1995 - 1996 Corvette: Service Bulletin: Transmission Fluid Leak From Pump Body

Subject: Transmission Fluid Leak From Pump Body (Replace Bushing)

Bulletin Number: 57-71-26B

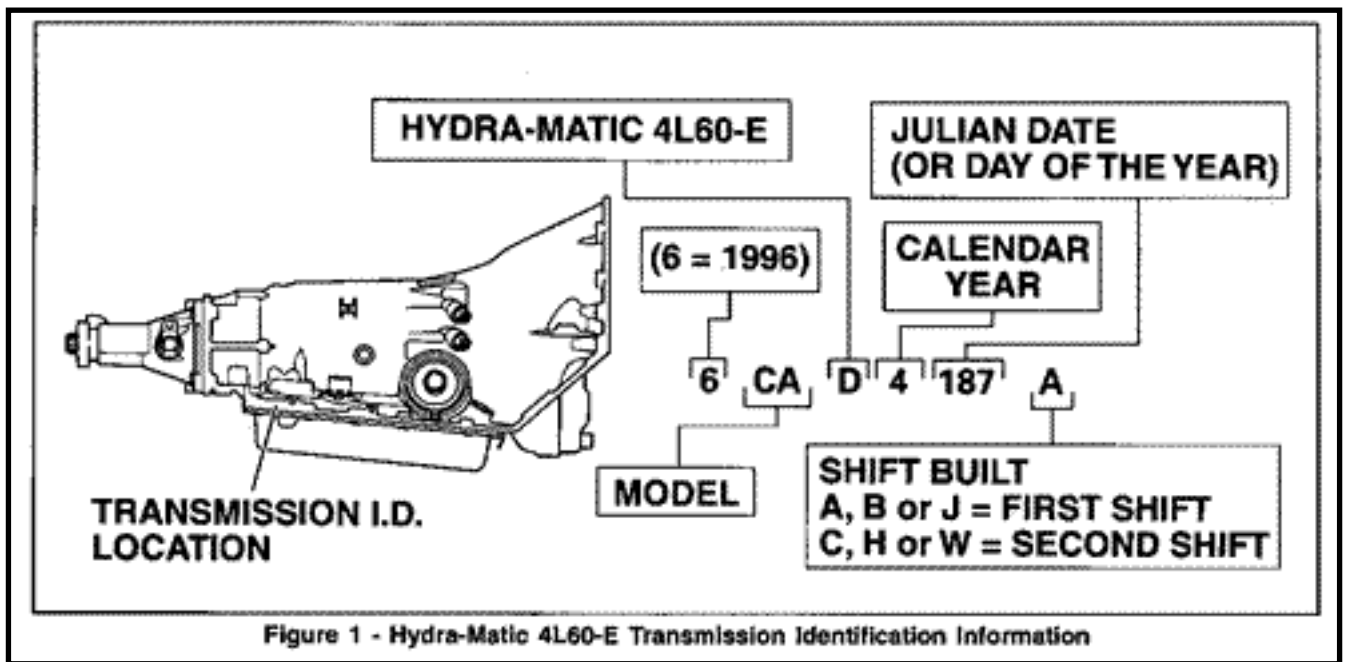
(FIGURE 1) SOME OWNERS MAY EXPERIENCE A PUMP FLUID LEAK. STARTING SEPTEMBER 11, 1995 (JULIAN DATE 254) ALL UNITS ARE BUILT USING A REVISED DESIGN BODY BUSHING.

THE PUMP BUSHING IS SPINNING OR WALKING OUT OF THE BODY.

REPLACE THE PUMP BODY BUSHING USING KENT-MOORE TOOL J41778.

Figure 2 - Remove Front Helix Retainer

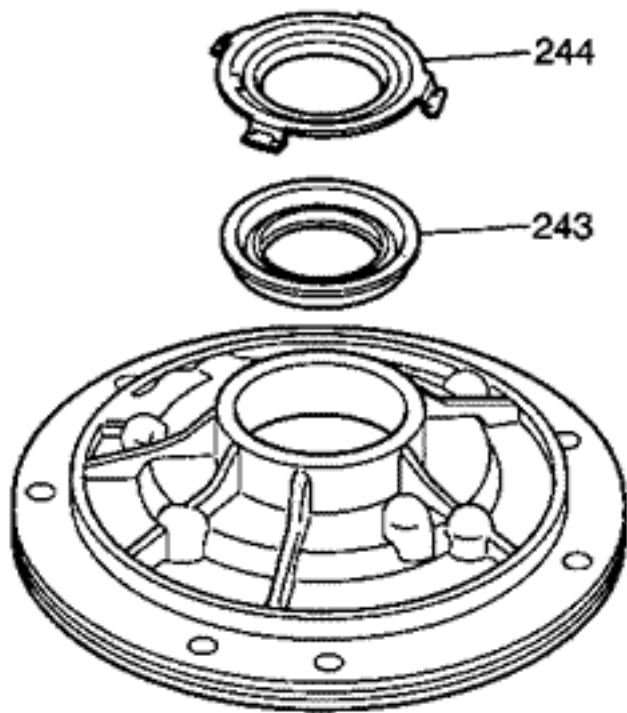
1. REMOVE THE FRONT HELIX RETAINER (244). 2. REMOVE THE OIL SEAL ASSEMBLY (243). 3. REMOVE THE PUMP BODY BUSHING (242) USING TOOL J41778-1. 4. INSTALL NEW BUSHING USING J41778-2 AS A POSITIVE STOP AND AN ARBOR PRESS WITH J41778-1.
